Comments on “Development of Cross-Polar Orientation-Insensitive Chipless RFID Tags”

O. Rance, N. Barbot, E. Perret

Abstract— In [1], the authors present a technique for designing resonant scatterers that display a cross-polarization reflection that remains consistent (i.e. non-zero) regardless of the orientation of the target. The authors claim that this property can be obtained simply by duplicating, rotating and arranging the position of a unit cell. We will show in this comment that all the design techniques presented in [1, Sec. III] lead to multiple cancellations of the cross-polarization component of the backscattered E-field. Therefore, the measurement results presented in [1] cannot be justified by the theory presented in section III of the same article.

Fig. 1. Angular coverage of the individual dipoles and of the total unit cell. This figure should be compared with [1, Fig. 3] which uses scalar summation.

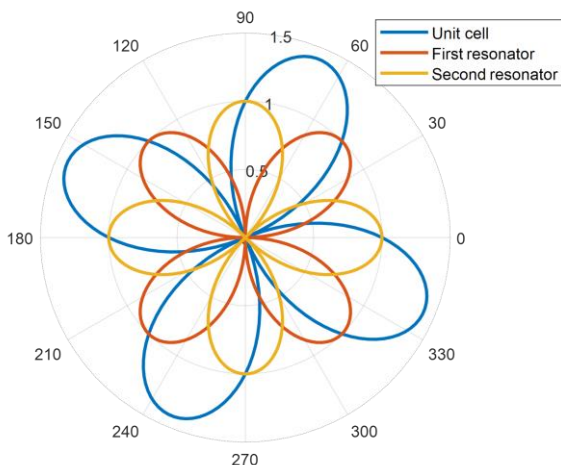
The methodology introduced by the authors to design cross-polar orientation-insensitive chipless tags is illustrated in [1, Fig. 3]. Two dipoles type scatterers oriented respectively at 0° (\mathbf{S}_1) and 45° (\mathbf{S}_2) are combined in order to improve the angular coverage of the total unit cell. The scattering matrix of the total target is given using superposition principle by:

$$\mathbf{S}(0) = \mathbf{S}_1(0) + \mathbf{S}_2(0) = A \cdot \begin{bmatrix} 1 & 0 \\ 0 & 0 \end{bmatrix} + A/2 \cdot \begin{bmatrix} 1 & 1 \\ 1 & 1 \end{bmatrix} \quad (4)$$

Using (3), this gives:

$$S_{vh}(\theta) = A/\sqrt{2} \cdot \cos(2\theta + \pi/4) \quad (5)$$

which appears to be zero for $\theta = 22.5^\circ$ [90°]. The graphical representation of $S_{vh}(\theta)$ normalized by A has been plotted in Fig. 1 for comparison with [1, Fig. 3]. The curves are identical for the first and the second resonators but the unit cell exhibits four nulls contrary to the scalar summation presented in [1]. Therefore, the unit cell shows no improvement in terms of angular coverage compared to the individual dipoles.
